## Product Change Notification

**1. ECR #:** 169112  
**Notification #:** 412

**3. Series:**  
• TFM - .050 X .050 MICRO STRIPS

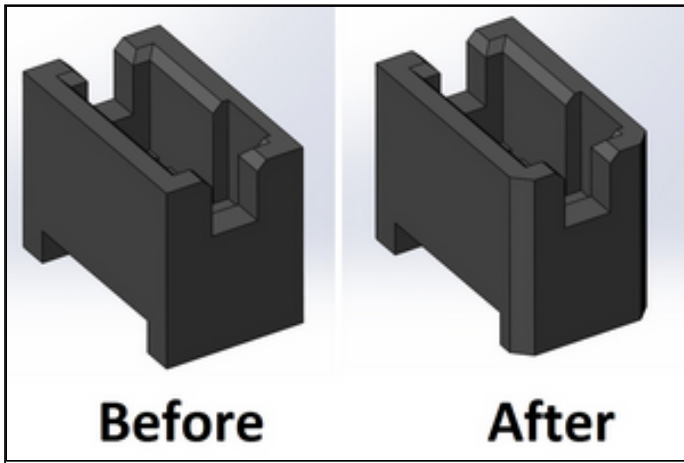
**5. Description of Change:**  
Form change: Chamfers were added to the edge of the plastic insulator body to polarize orientation within tape & reel.

**6. Method of Identifying Change**  
Visual: Chamfers are visible with unaided eye

**8. Impact of Change on Form, Fit, or Function:**  
• Form - Added chamfers are visible under 10X magnification
